Response to TCB Findings

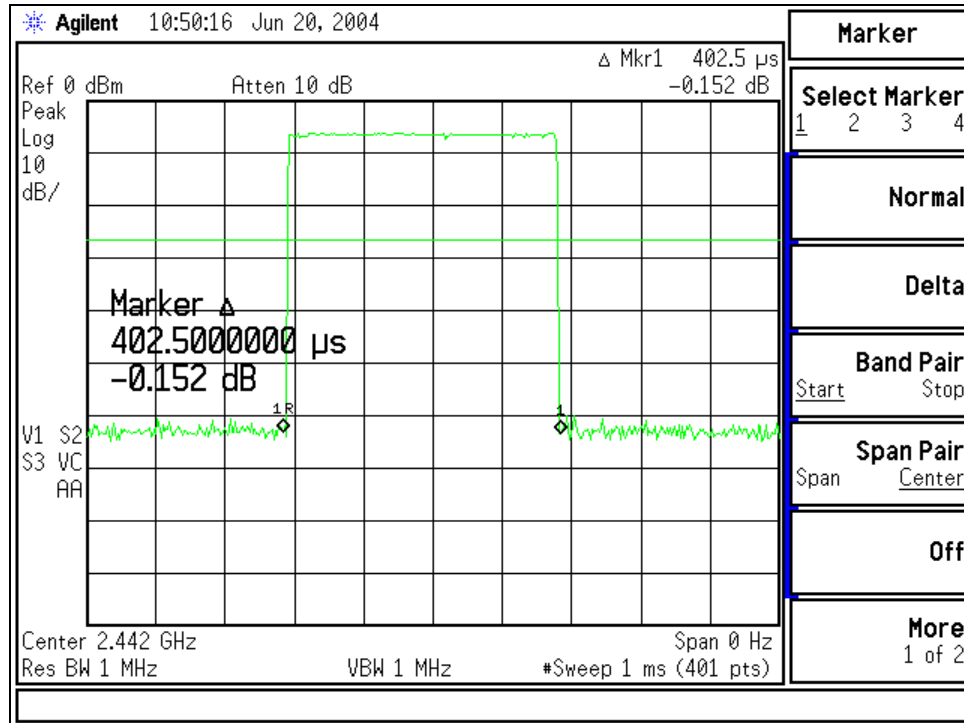
6. **Please supply details of channel occupancy (1.24ms) calculation with supporting plots. For example: During (0.4s x 93 channels) interval how many times did the transmitter activate and how long is the single activation?**

Plots are contained at the end of this document.

Channels 0 to 19

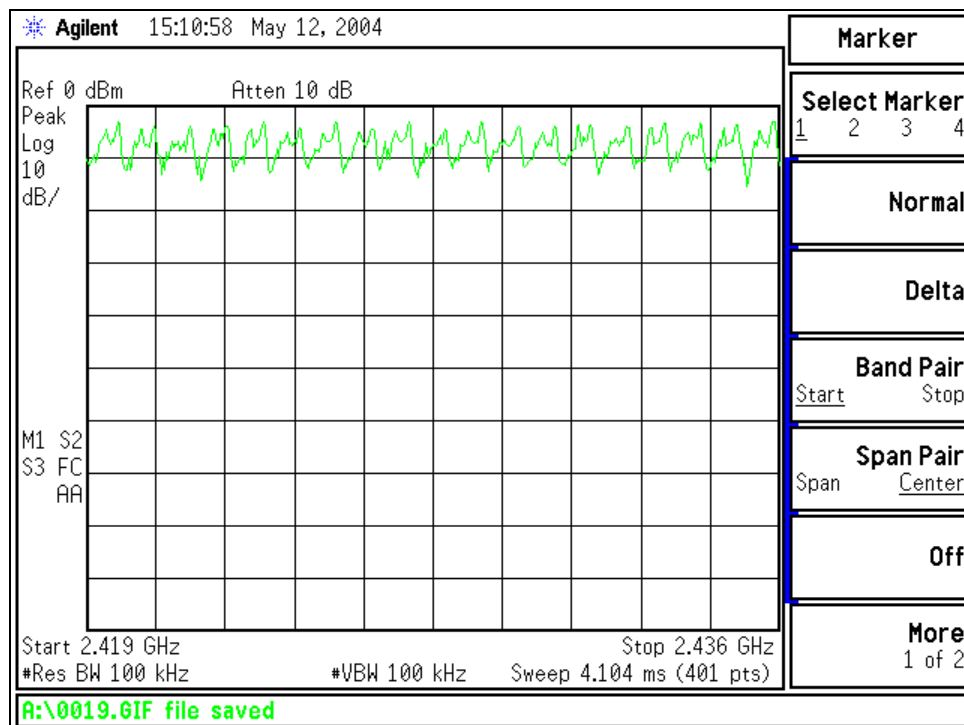
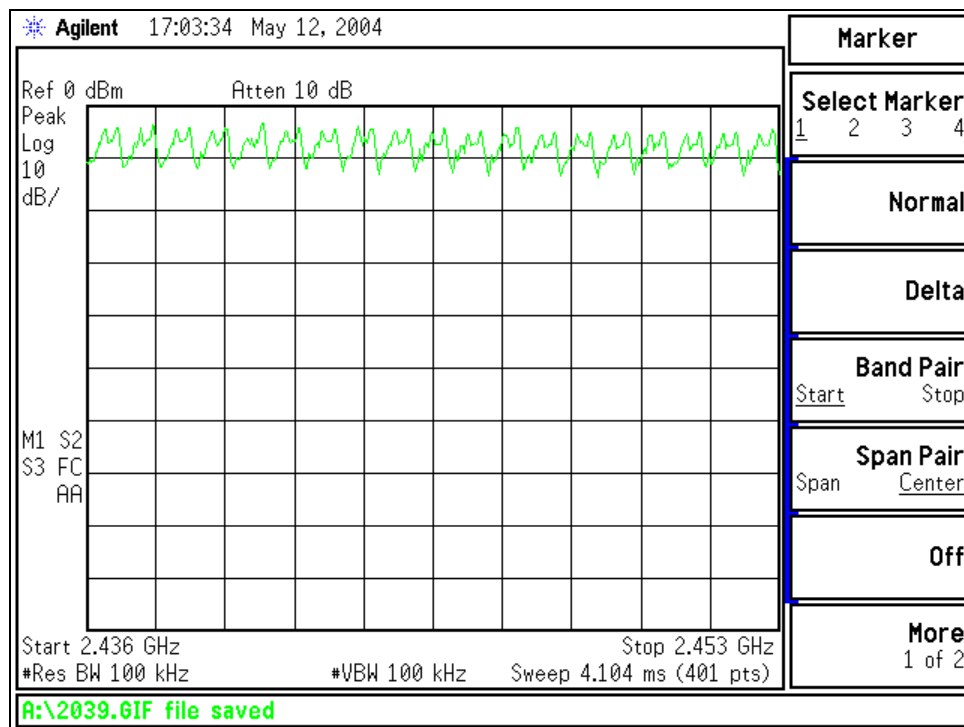
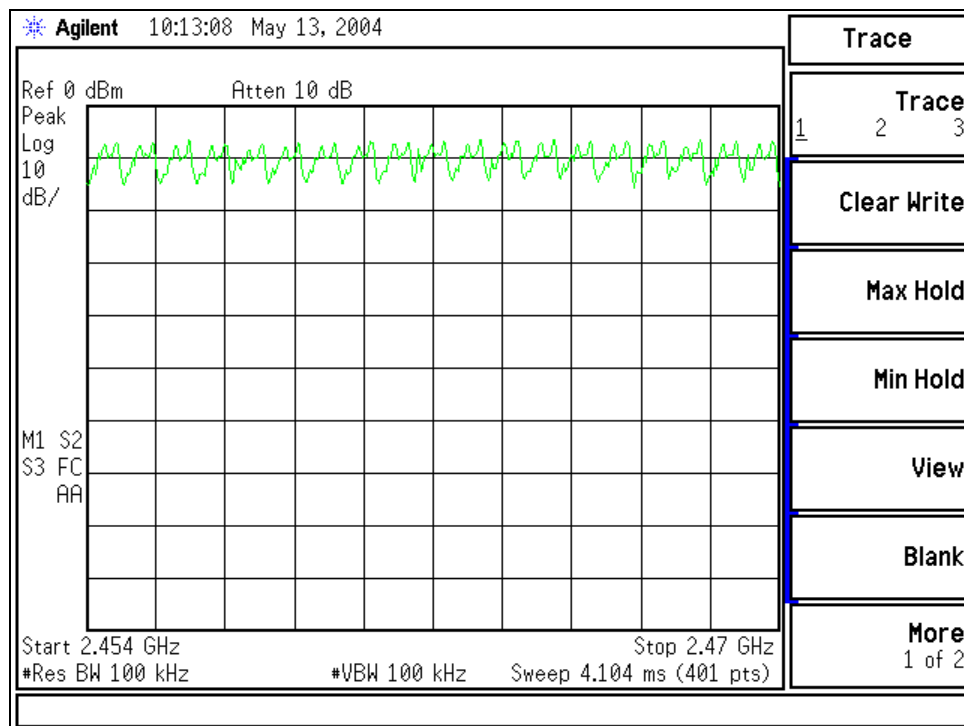
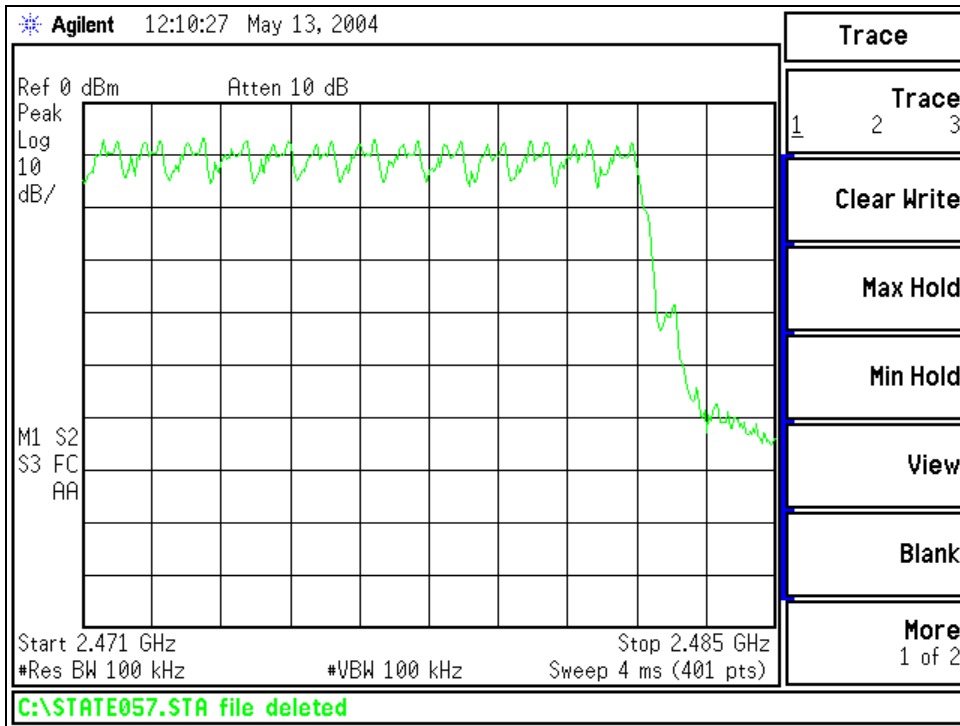
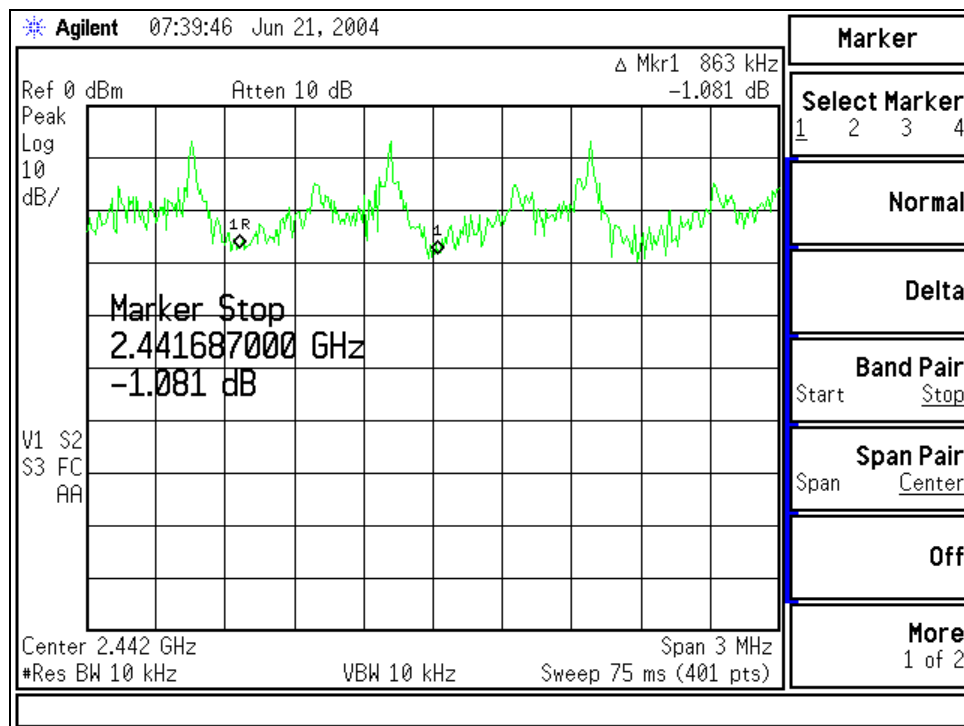
4. **Please confirm that the public notice DA 00-705 was used for test procedures. Please supply plots for 20dB bandwidth and number of hopping channels tests.**

Confirmed that public notice DA 00-705 was used for test procedures. Plots are contained at the end of this document.
